SUSQUEHANNA SES UNIT 1 CYCLE 6

TECHNICAL SPECIFICATION
CHANGES

June 1990

PENNSYLVANIA POWER & LIGHT COMPANY

Figure 3.4.1.1.1-1
THERMAL POWER RESTRICTIONS

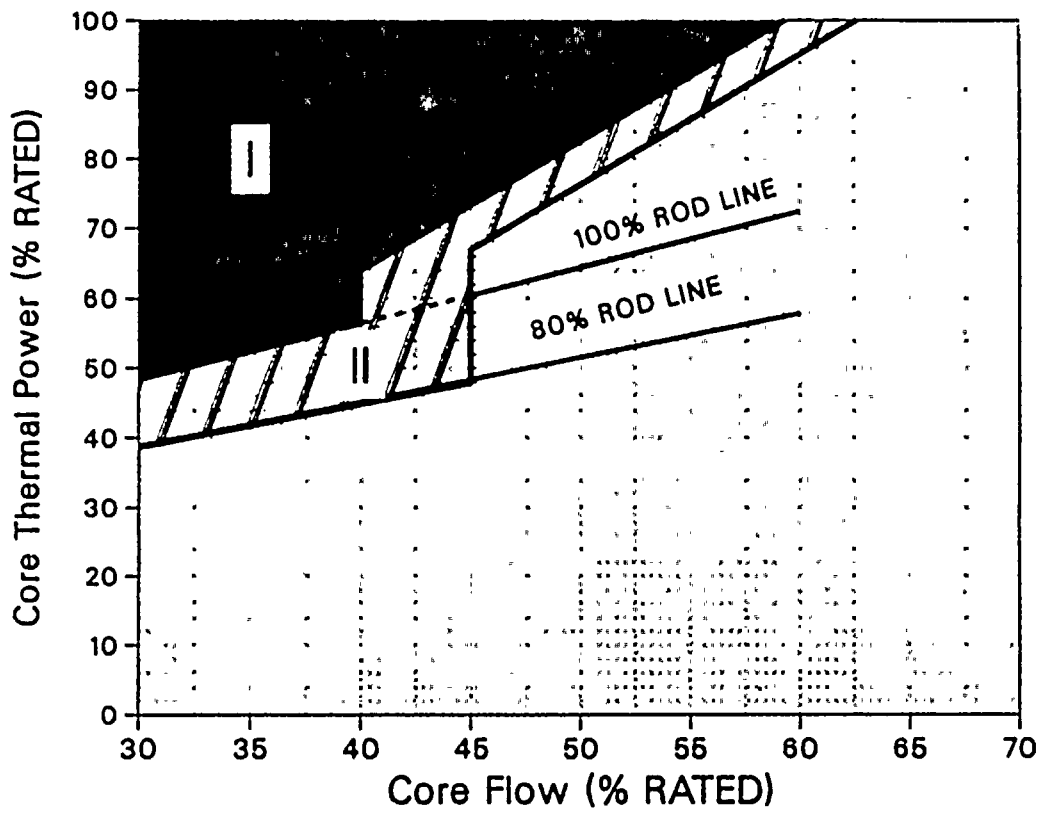
Replace with the figure on following page

The changes to this specification (i.e., Figure 3.4.1.1.1-1) reflect cycle-specific stability analysis.

Region I has been defined such that the decay ratio for all allowable power/flow conditions outside of the region is less than 0.90. To mitigate or prevent the consequences of instability, entry into this region requires a manual reactor scram. Region I for Unit 1 Cycle 6 has been calculated to be slightly larger than Region I for the previous cycle.

Region II has been defined such that the decay ratio for all allowable power/flow conditions outside of the region (excluding Region I) is less than 0.75. For Unit 1 Cycle 6, Region II must be immediately exited if it is inadvertently entered. Similar to Region I, Region II is slightly larger than in the previous cycle.
